## *City of El Paso – City Plan Commission Staff Report*

**Case No:** SUSU14-00047 Valley View Park  
**Application Type:** Major Combination  
**CPC Hearing Date:** June 19, 2014  
**Staff Planner:** Alejandro Palma, (915) 212-1607, palmaaj@elpasotexas.gov  
**Location:** South of Carolina Drive and West of Yarbrough Drive  
**Acreage:** 4.41 acres  
**Rep District:** 7  
**Existing Use:** Vacant  
**Existing Zoning:** C-1 (Commercial)  
**Proposed Zoning:** C-1 (Commercial)  
**Nearest Park:** Green Lilac Park (.11 miles)  
**Nearest School:** Hillcrest Middle (.34 miles)  
**Park Fees Required:** \$4,400.00  
**Impact Fee Area:** N/A  
**Property Owner:** Readek Group LLC  
**Applicant:** Plaza Engineering Consultants  
**Representative:** Plaza Engineering Consultants

**ATTACHMENT 3**

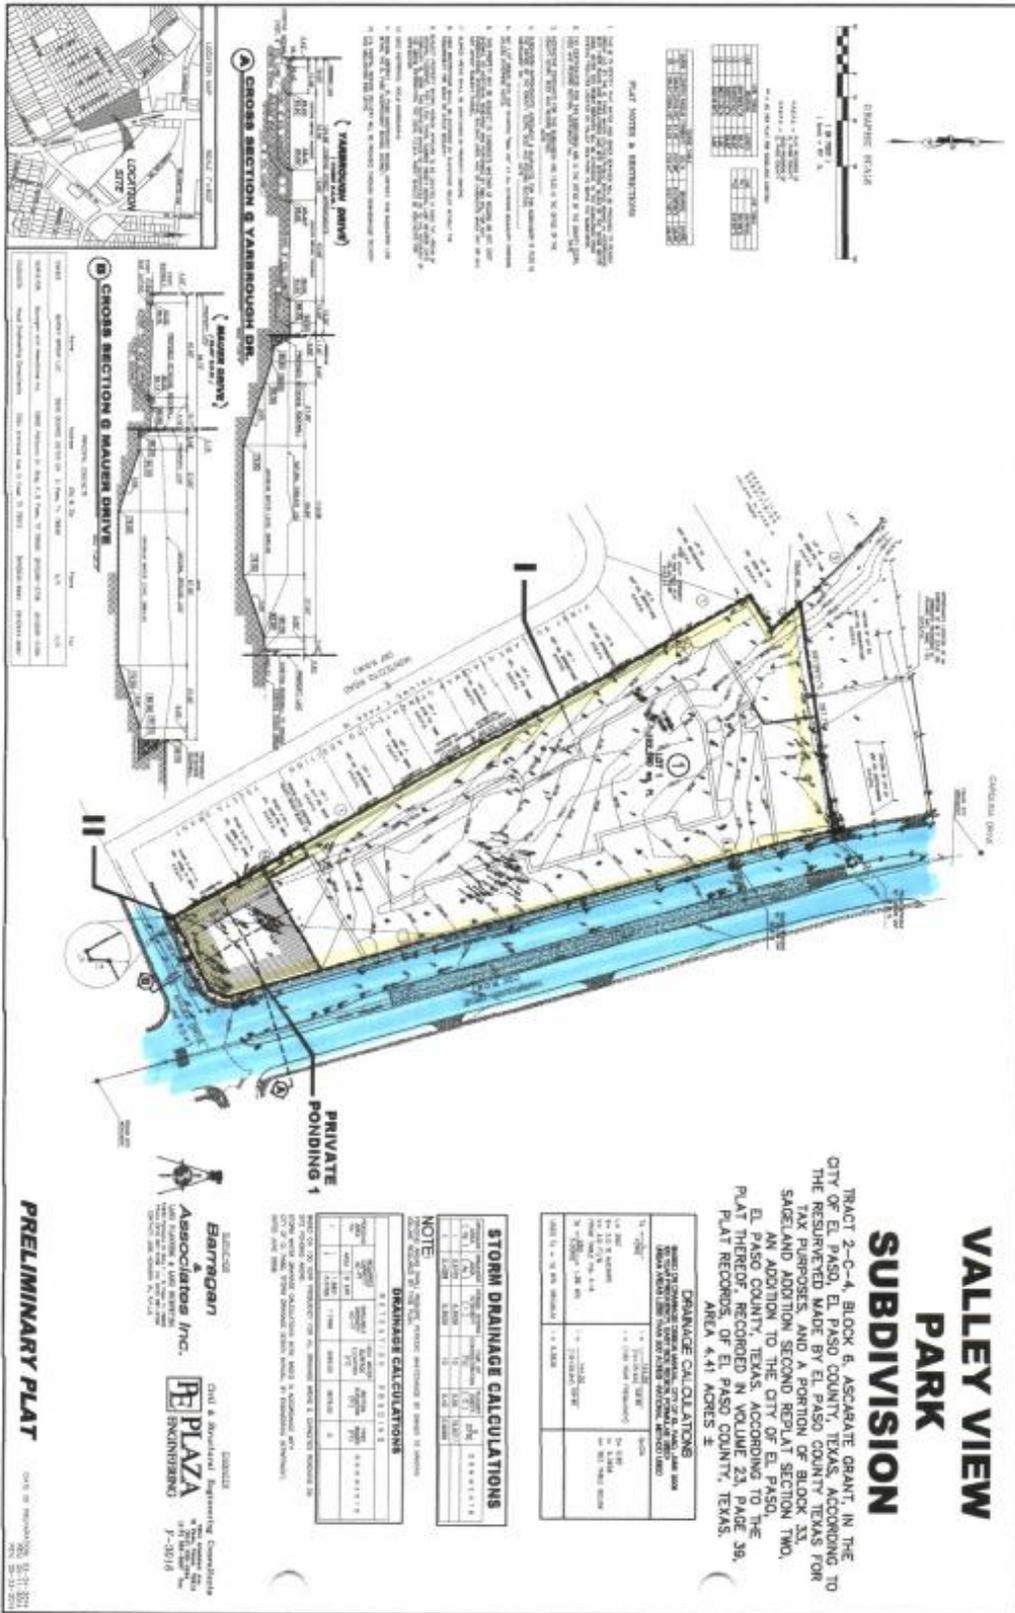
2. There is an existing 6-inch diameter water main extending along Yarbrough Dr., ending at the most northern boundary line of the property.
3. There is an existing 6-inch diameter water main extending along Yarbrough Dr. located approximately 39 feet east of the street centerline. This main is available for service.

4. There is an existing 6-inch diameter water main extending along Mauer Dr. ending approximately 122 feet east of the intersection of Montecito and Mauer St. The main is located approximately 12 feet south of the street centerline.
5. Previous water pressure tests from fire hydrant # 5829 fronting the subject property along Yarbrough Dr., yielded a static pressure of 90 (psi) pounds per square inch, a residual pressure of 85 (psi) pounds per square inch, and a discharge of 1113(gpm) gallons per minute.
6. The owner should, for his own protection and at his own expense, install at the discharge side of each water meter a pressure regulator, strainer and relief valve, to be set for pressure as desired by the customer. The Lot owner shall be responsible for the operation and maintenance of the above-described water pressure regulating device.

7. There is an existing 8-inch diameter sanitary sewer main extending along Yarbrough Dr., located approximately 10 feet east of the property's eastern boundary line. This main is available for service.
8. There is an existing 6-inch diameter sanitary main that extends along Yarbrough Dr. located approximately 50.5 feet east of the right of way centerline.
9. There is an existing 8-inch diameter sanitary sewer main that extends along the Mauer Dr. This main is available for service.

10. Water and sewer service for the subdivision may require extensions from the water and sewer mains along Yarbrough Dr. and Mauer Dr. Easements are required to be dedicated to accommodate on-site public water and public sanitary sewer mains.

**ATTACHMENT 4**

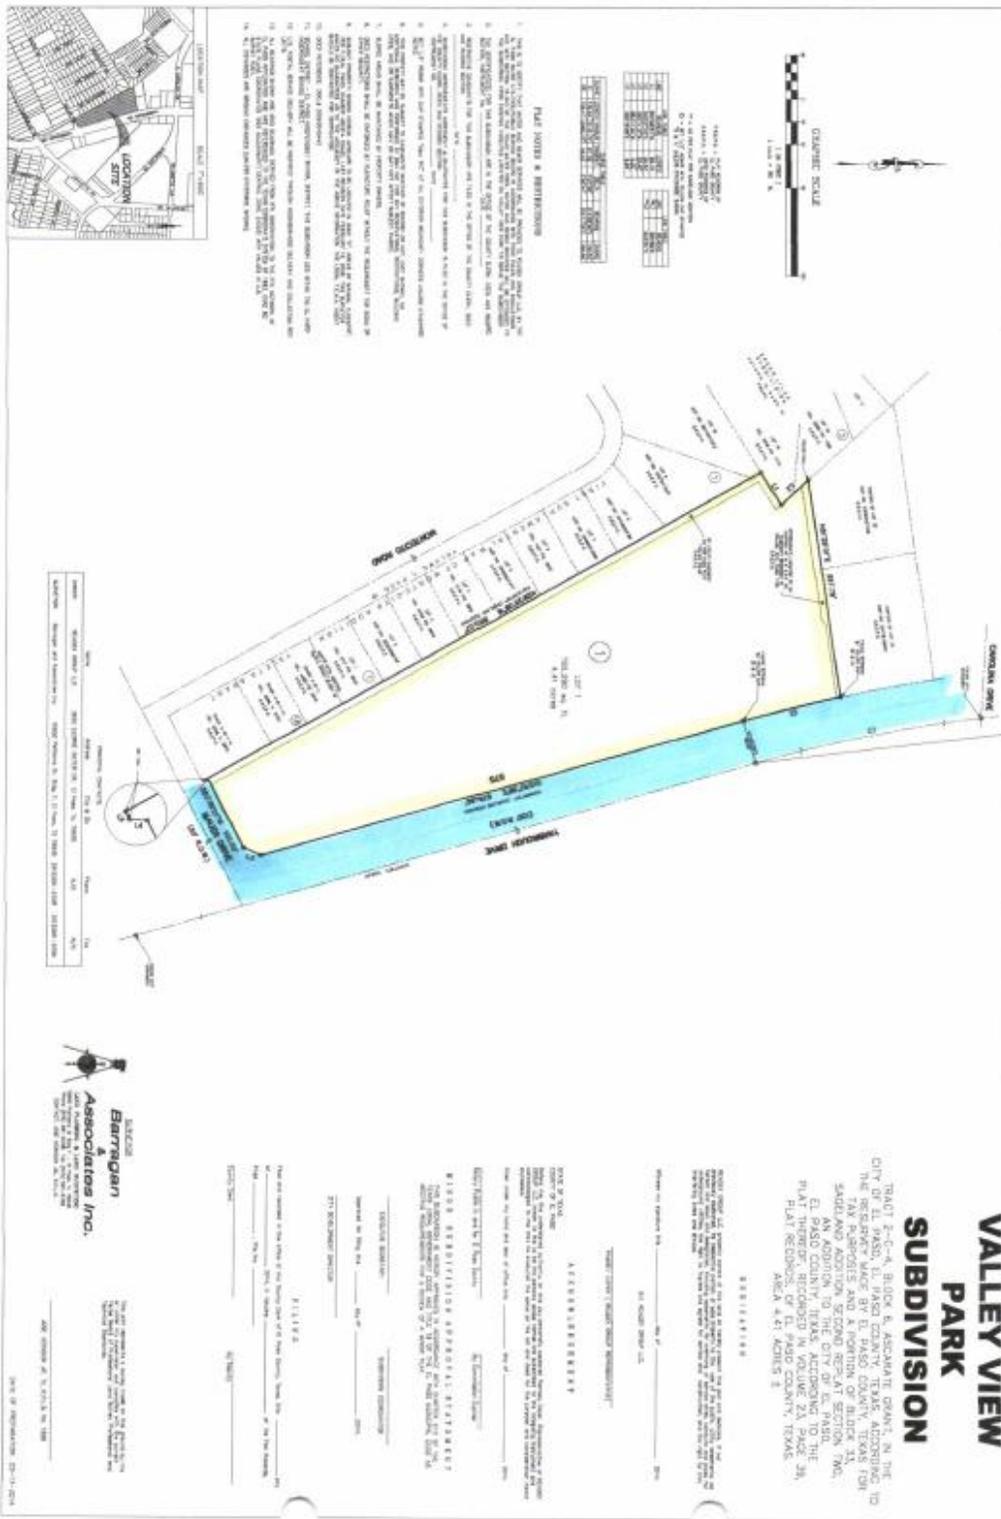
Please note that this subdivision is zoned "C-1" meeting the requirements for multi-family dwellings use restricted to a maximum of 29 dwelling units per acre however, applicant has submitted a "**revised**" copy of the final covenants restricting the use to "General Commercial" purposes and prohibiting the construction of Multi-family dwelling units unless owner pays appropriate "Park fees" before a "Building Permit" is issued for this parcel therefore, "Park fees" are due in the amount of **\$4,400.00** calculated as follows:

Non-residential subdivision acreage **4.4** (rounded to two decimals) @ \$1,000.00 per acre = **\$4,400.00**
